Addendum No. 2

Project: Fort Wayne International Airport
Construct Taxiway G Extension & Demolish Taxiway C2
AIP No. 3-18-0022-XX

Date: June 20, 2024

Designed By:	Drawn By:	Checked By:
RB	KDR	NSL
Issue Date:	Project No:	Scale:
05/28/2024	075494	AS SHOWN
Drawing No.:		
C4.1.2

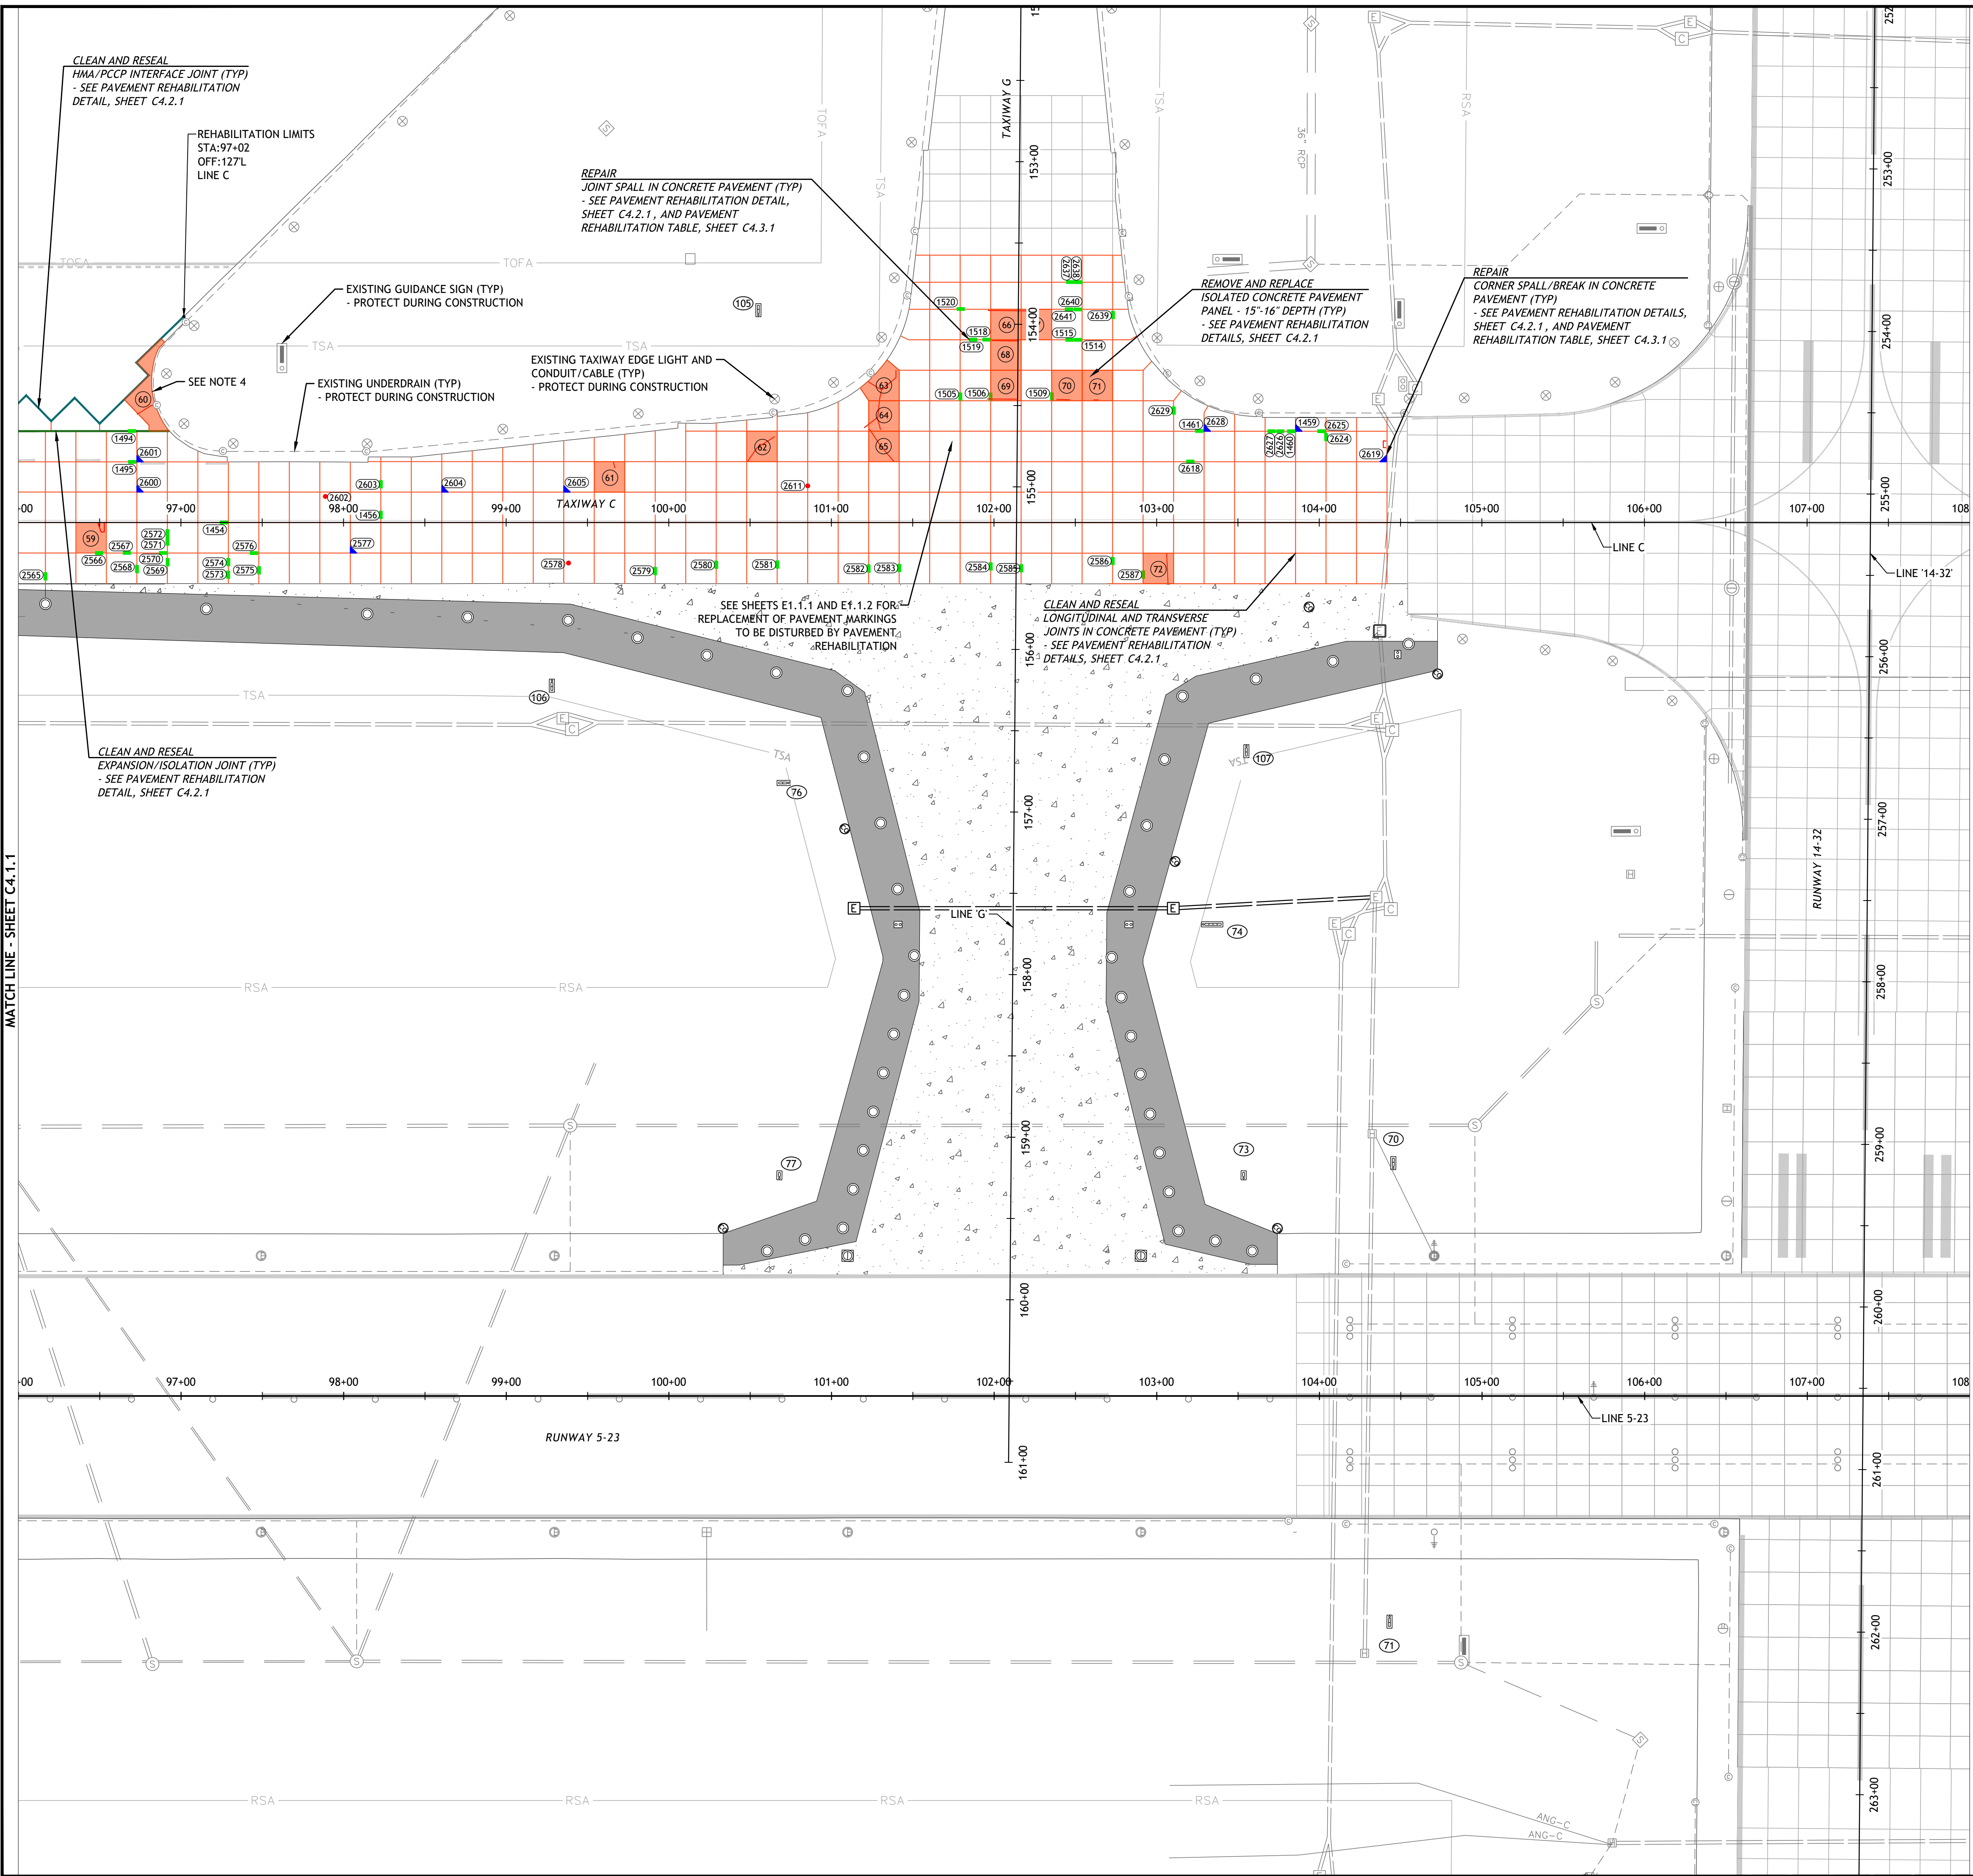
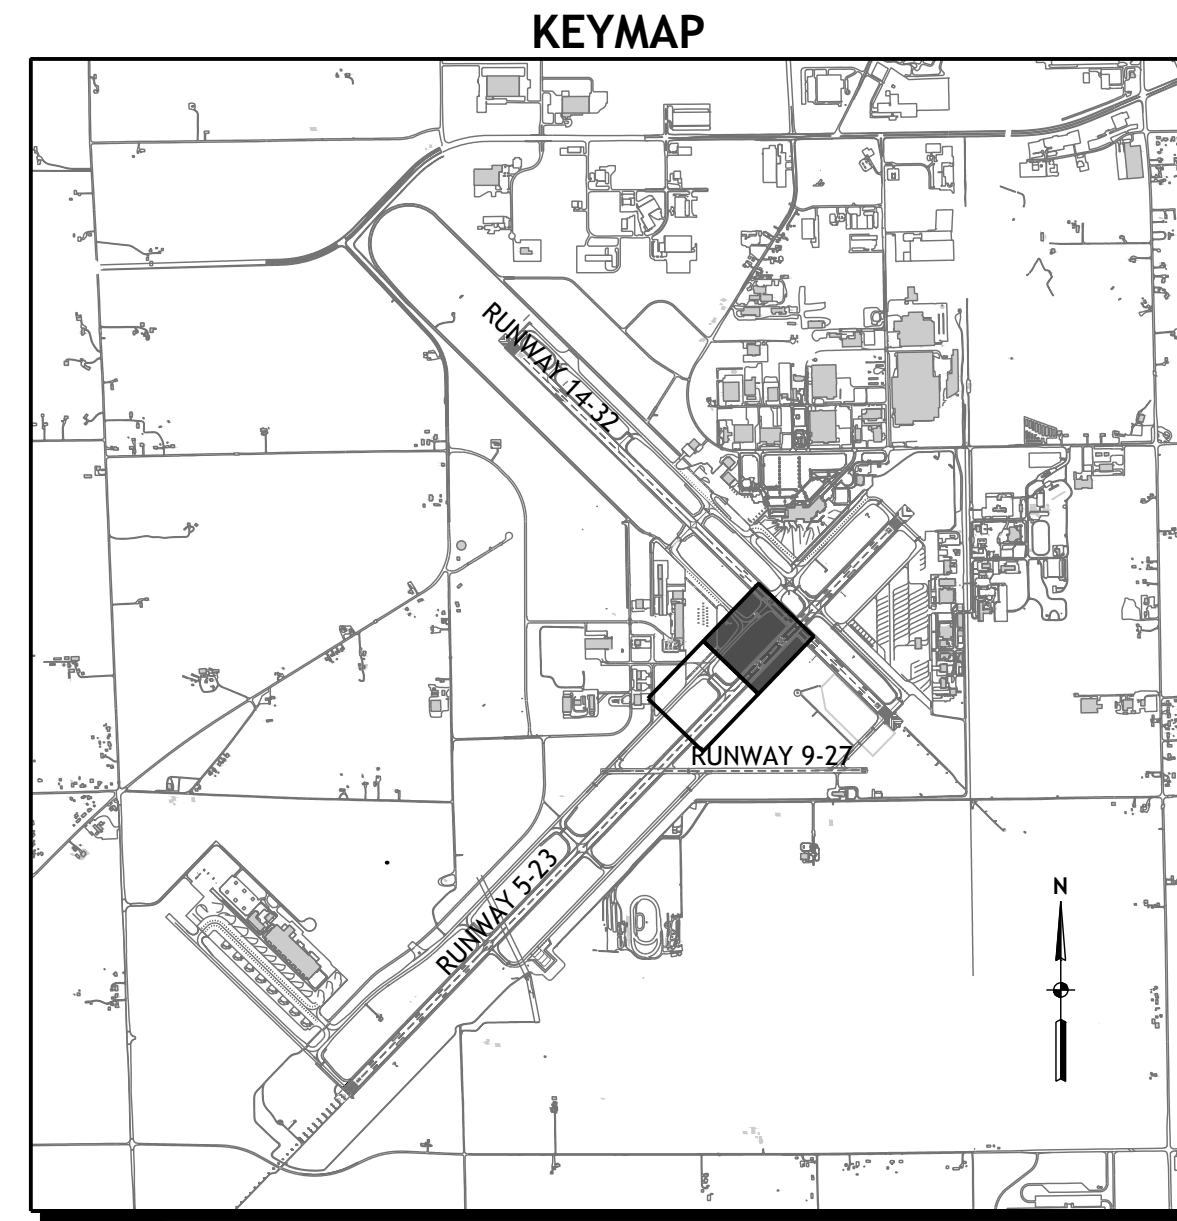
Issued: New sheet has been added to reflect proposed pavement repairs to Taxiway C between the West Apron and Runway 14-32.
